# Experience Quarter (EQ)

## Bicester Motion

Client:	Bicester Motion	Job No	J323684
Date:	03 September 2021	Approved by:	BDF/DJF
Prepared by:	ALF

## Walking & Cycling Infrastructure – Response to OCC

**Figure Number**  
 EQ1

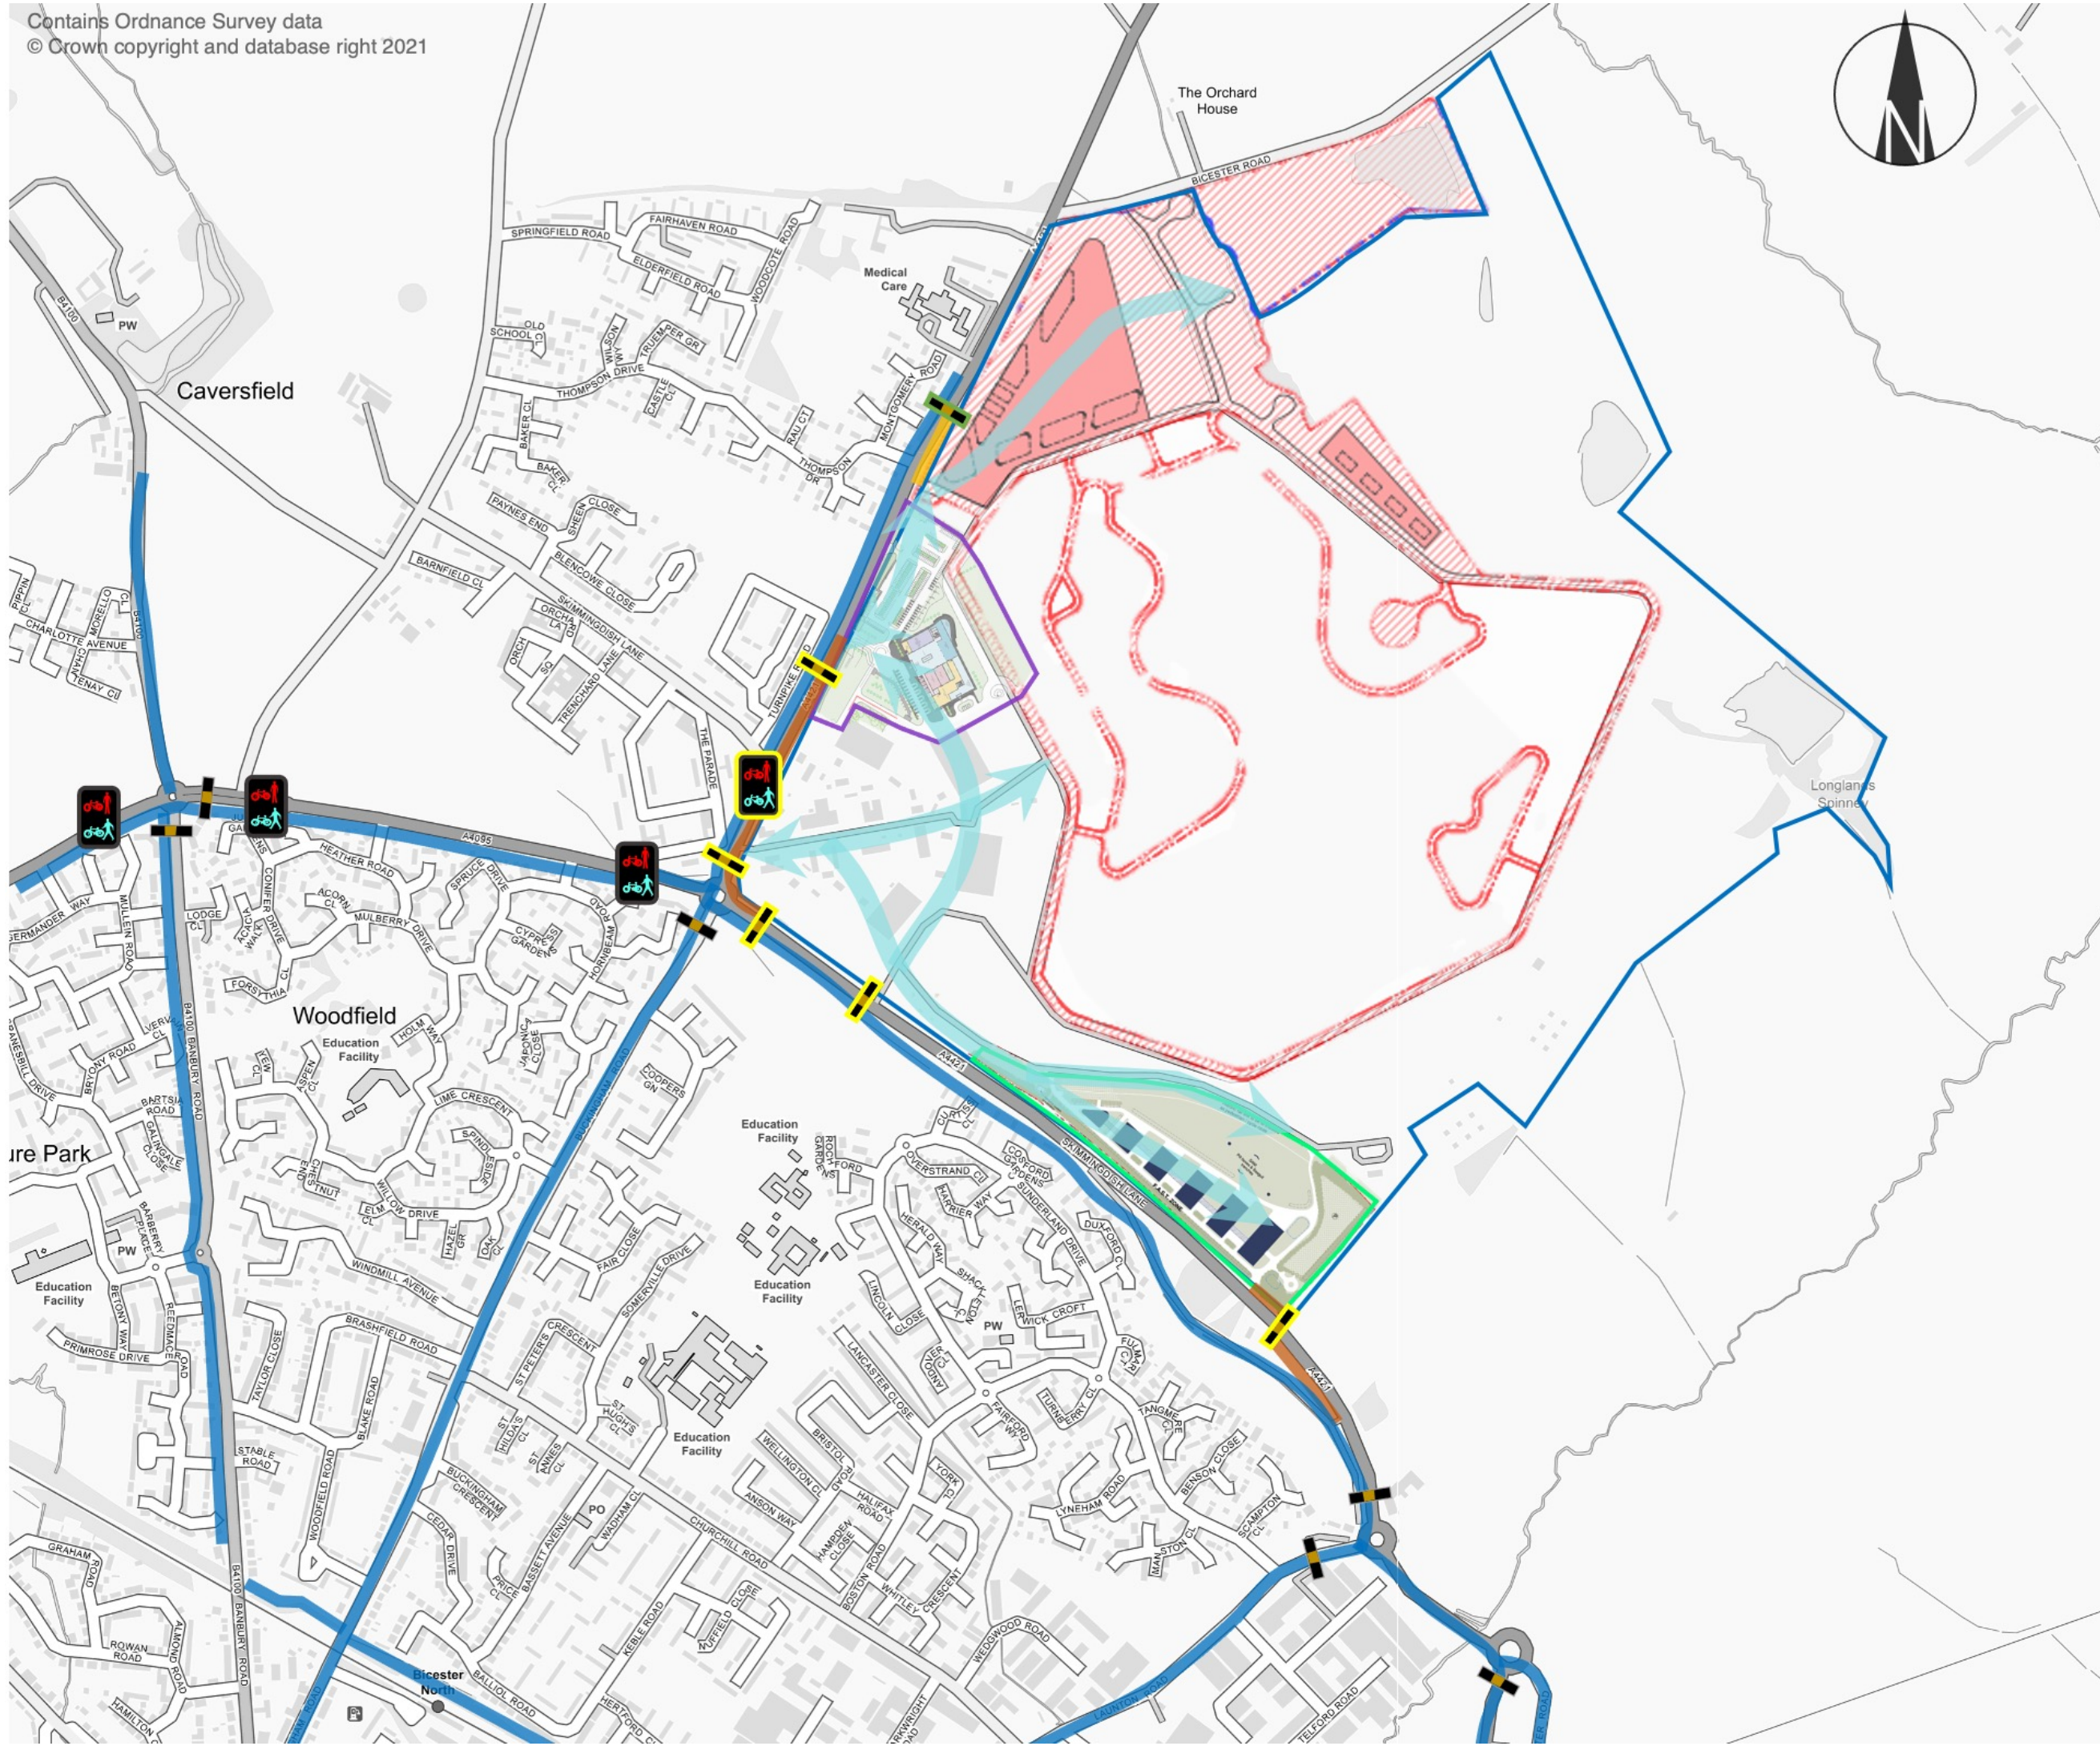
*Recently permitted developments on the wider Bicester Motion site are to provide sections of footway / cycleway on the eastern side of Skimmingdish Lane, up to the Bicester Motion Hotel site access.*

*However, this proposal does not propose a continuation of that footway / cycleway up to the new access. The only pedestrian connection proposed for this development is a short section of footway to the north of the access junction and a tactile crossing to take visitors to the western side of Skimmingdish Lane.”*

- 1.2.22 **OCC comment:**
- “The development is likely to lead to an increase in visitors to the lake area, however there are no pedestrian facilities along Bicester Road where access to the lake is to be taken. This could potentially be overcome through improved public access route(s) through the site.”*

- 1.2.3 As referenced above (& by OCC), there are extents of 3m wide shared footway/cycleway proposed as part of recently permitted developments on the wider Bicester Motion site (i.e., and in particular, the Hotel and Command Works applications, refs: 18/01253/F & 18/01333/F, respectively); the proposals are for the EQ development to provide an internal pedestrian/cycle route and connection towards the hotel access (within Bicester Motion’s land boundary) which will link in with the proposed footway/cycleway on the eastern side of Buckingham Road. This is indicatively illustrated on the mode Walking/Cycling Movement Strategy Plan, attached to this note **Appendix A**, for reference.

- 1.2.23 Similarly to the proposed sustainable access to the EQ (from Hotel), as above, the intention is to provide internal footway/cycle connection routes from the EQ toward the lake area and future wider-masterplan development to the northwest; negating the need to provide infrastructure specifically adjacent to the Bicester Road carriageway. This again is indicatively illustrated on the Walking/Cycling Movement Strategy Plan, appended to this note, for reference.

drawing no.  
 J32-3684-PS-202

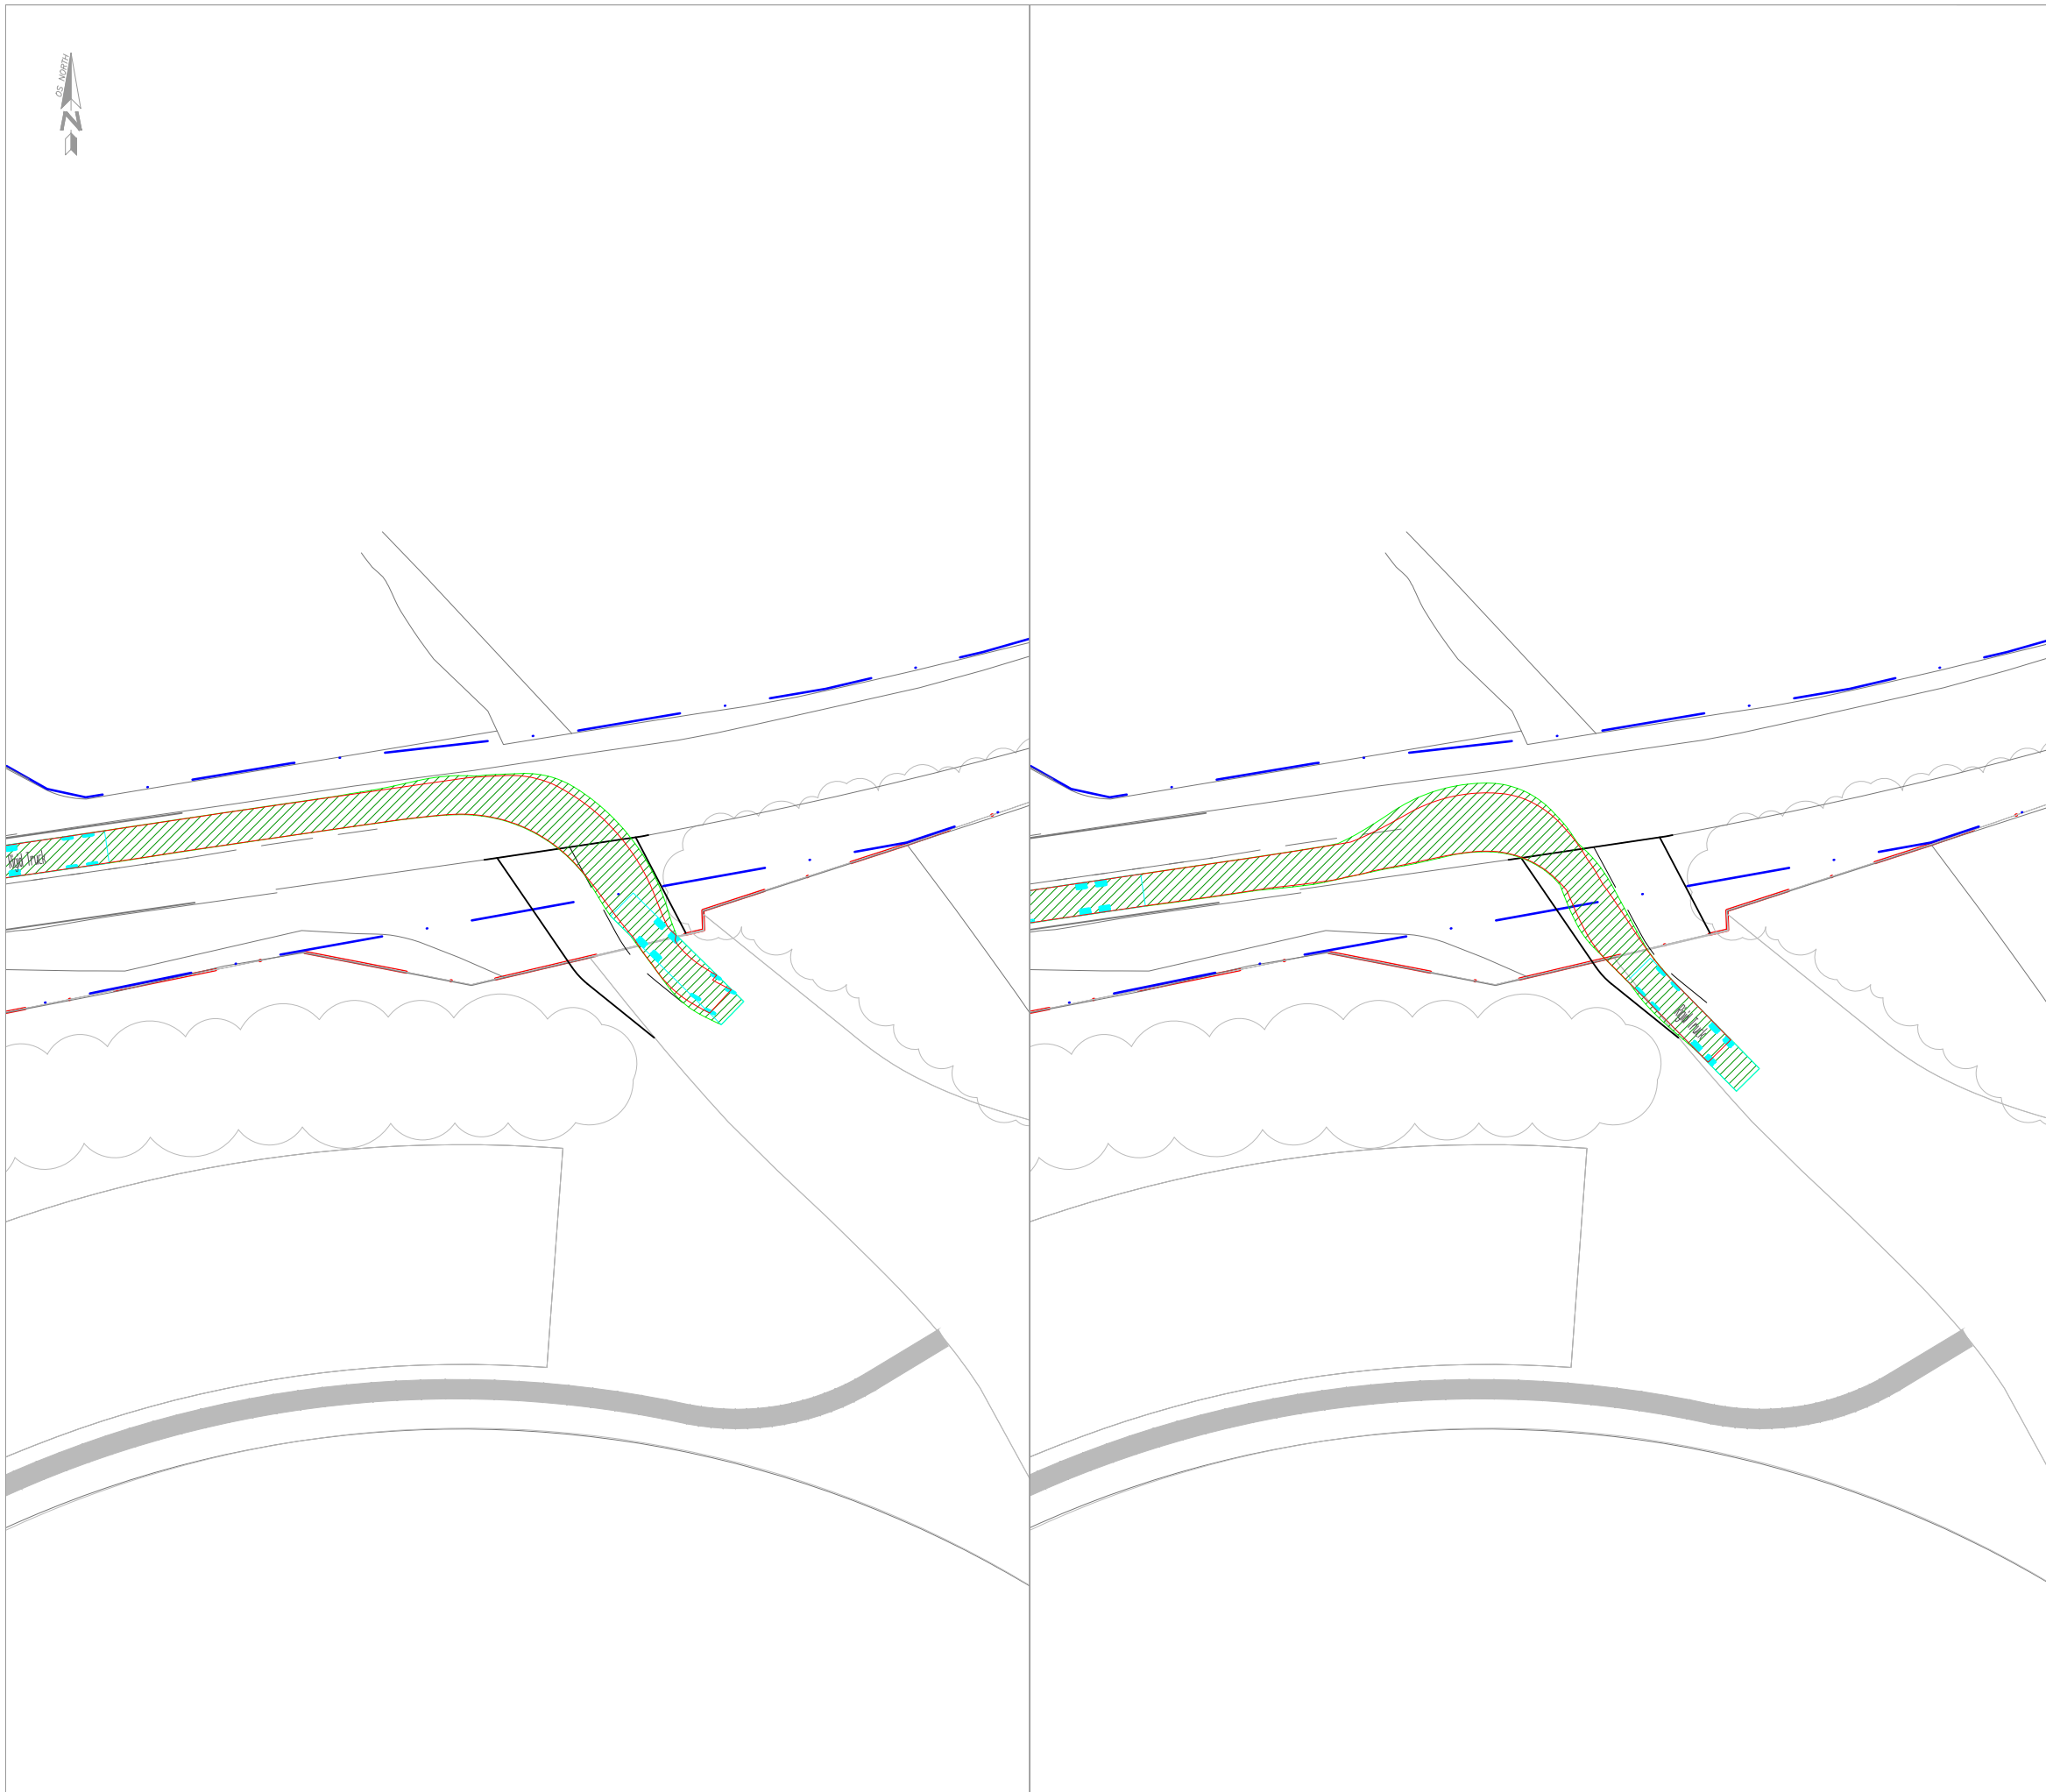
*“ Vehicle tracking is required at all junctions to demonstrate that the largest vehicles anticipated to require access to the site can safely and easily enter and exit.*

- 1.3.3 Vehicle tracking has been undertaken at the main site access on Buckingham Road and is shown on mode drawing **J32-3684-PS-202**, appended to this note, for reference (**Appendix B**). This demonstrates that a 12m rigid truck is able to safely and suitably access and egress the site’s main access in a forward gear.
